PROJECT: **NEW GENERATOR INSTALLATION FOR:**

SUPPORTING INDIVIDUALS WITH DISABILITIES FOR OVER 40 YEARS LOCATION: 500 NE COLBERN ROAD LEE'S SUMMIT, MISSOURI 64086

MECH ROOM REVISIONS 3

CIRCUIT REVISIONS TO EMERG PAN/ GEN SET 2

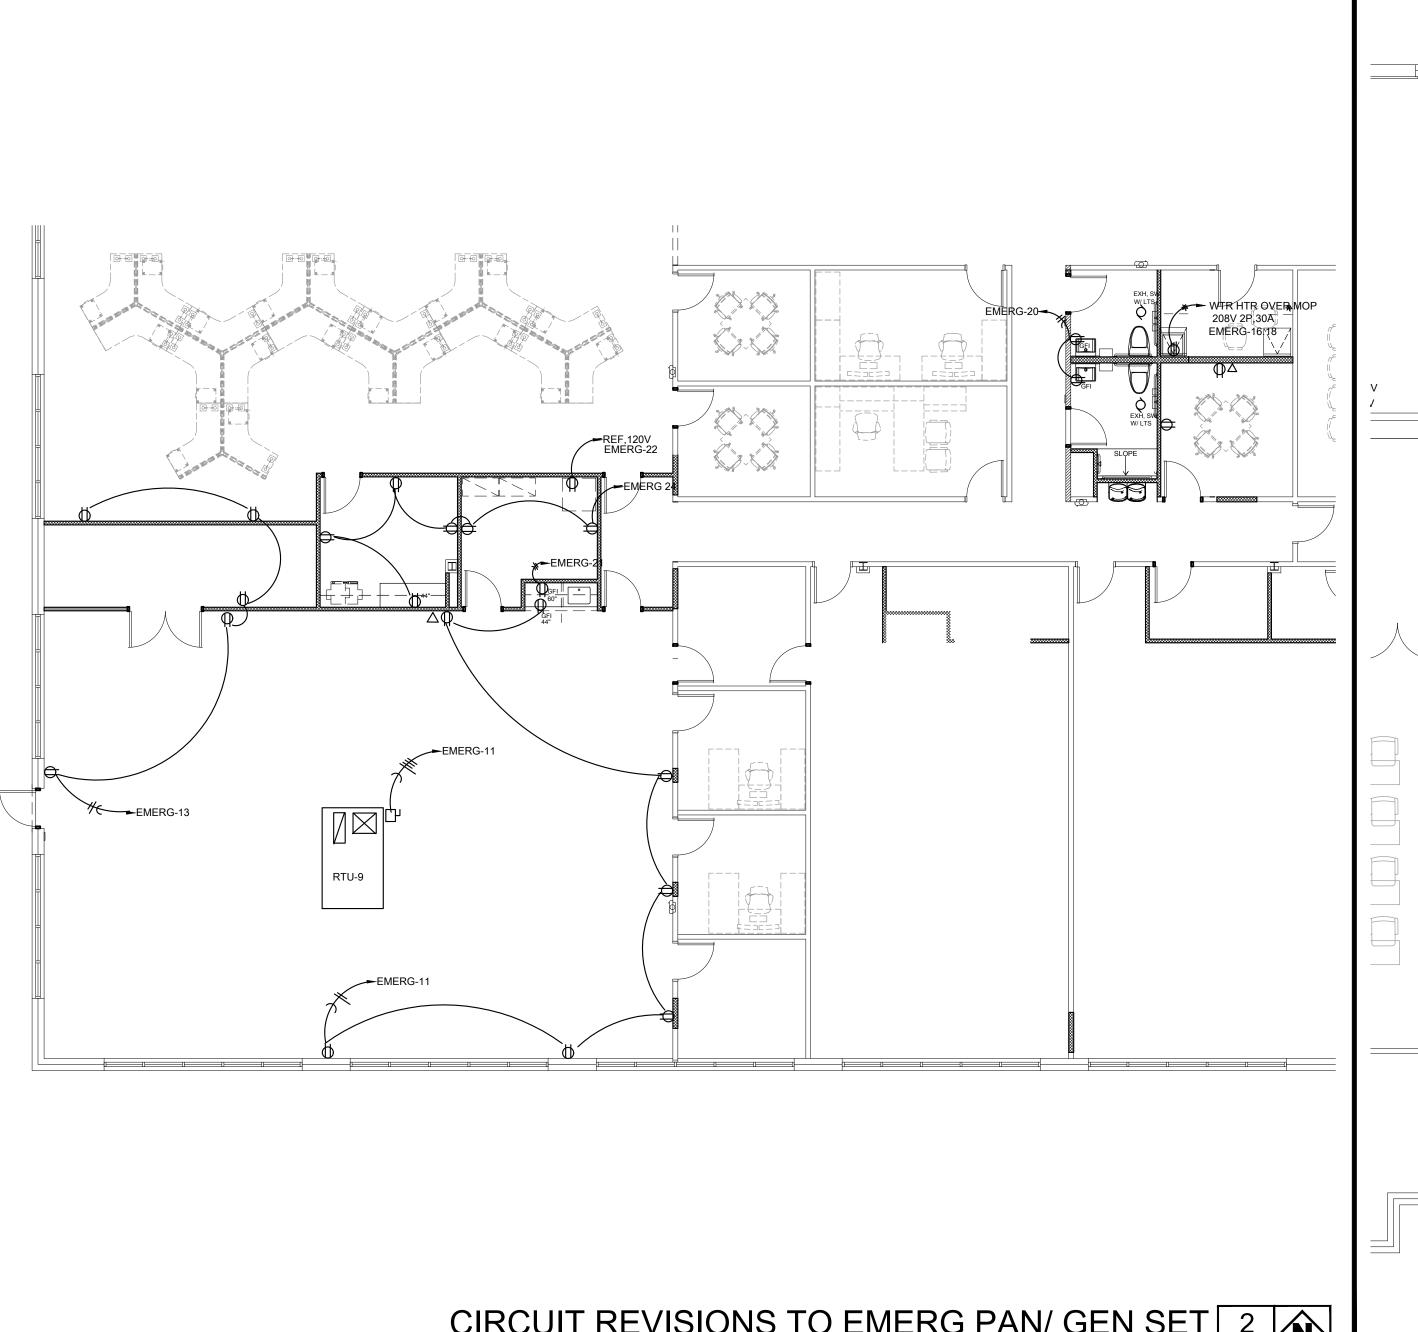
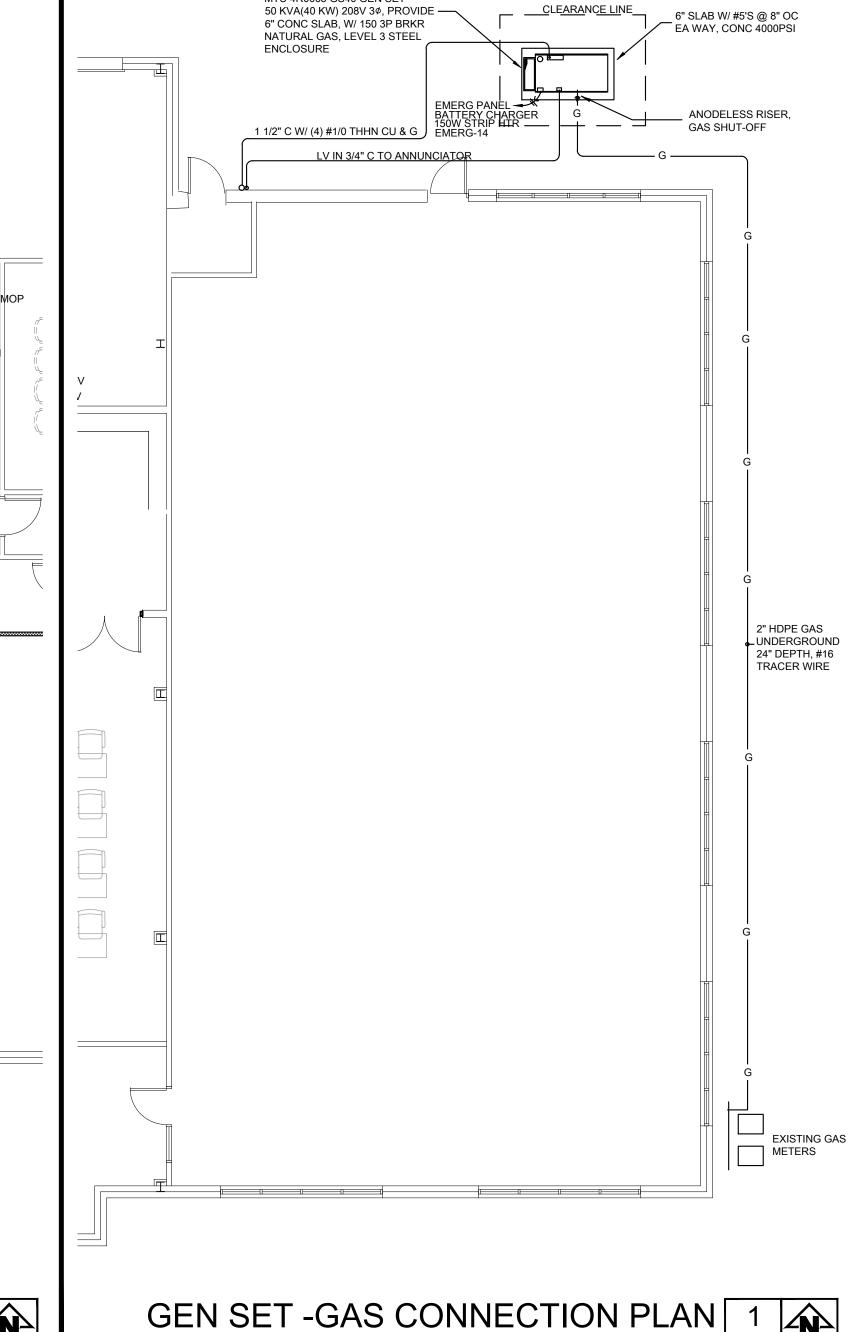
RELOCATE EXISTING LIGHTING CIRCS FROM EXISTING PANEL B TO EMERG PANEL. COMBINE CIRCUITS ONTO BRKRS (EMERG-25-33), EQUALIZE WATTAGE AS CLOSE AS POSSIBLE, TOTAL WATTAGE SHOULD BE APPROX. 4500W.
